KORDIN GRAIN TERMINAL MALTA  
(Contract no. 84/05/HR)  
AMENDMENT NO. 3 - FINAL REPORT

Report prepared for:  
United Nations Industrial  
Development Organization (UNIDO)  
Vienna, Austria.

January, 1986.

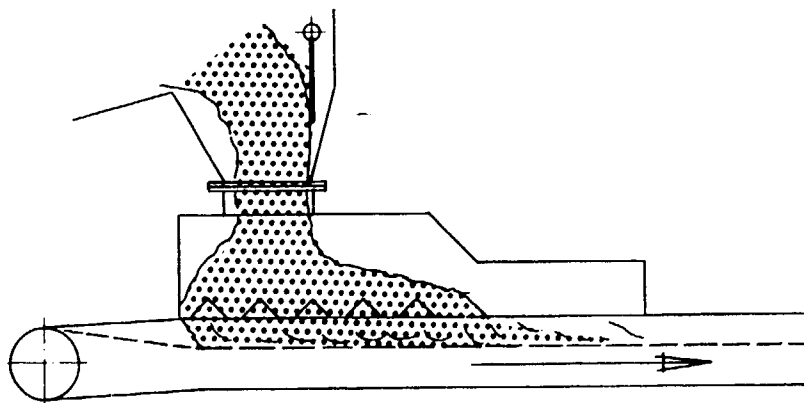
The yesterday placed temporarily additional steering plate in transferpoint from loading jib belt to portal belt the off-tracking of the belts slightly improved but did not give the required results.

- . After a period of time testing with 625 tons decided to test with two reclaiming lines at 1250 tons per hour. The behaviour of the belts was slightly better than with 625 tons but also did not give the results as expected.
- . Major changes to be carried out because off-track running of loading jib belt in most positions still exist,
- . Finished loading of the vessel with all the problems of the belt including occasionally malfunctioning of the de-dusting filters. Both problems have to be solved.

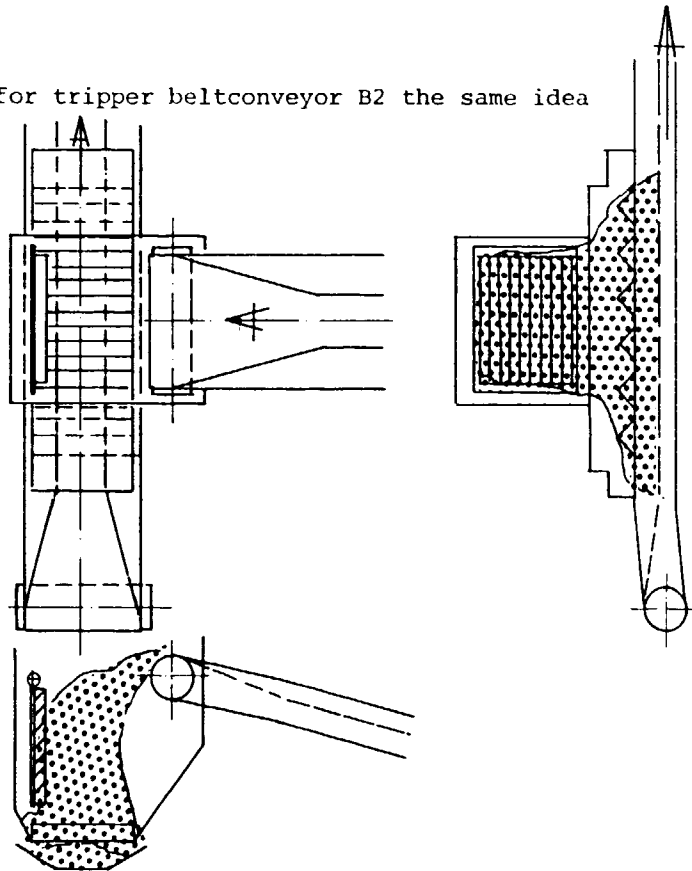
- (a) adjustable triangle shaped plates to be placed under the grain flow as follows.

The triangle shaped plates across the rotating loading shoe underneath the flow from portal belt conveyor transferpoint.

(b) for tripper beltconveyor B2 the same idea

Mr. O. Karz agreed with the above proposals
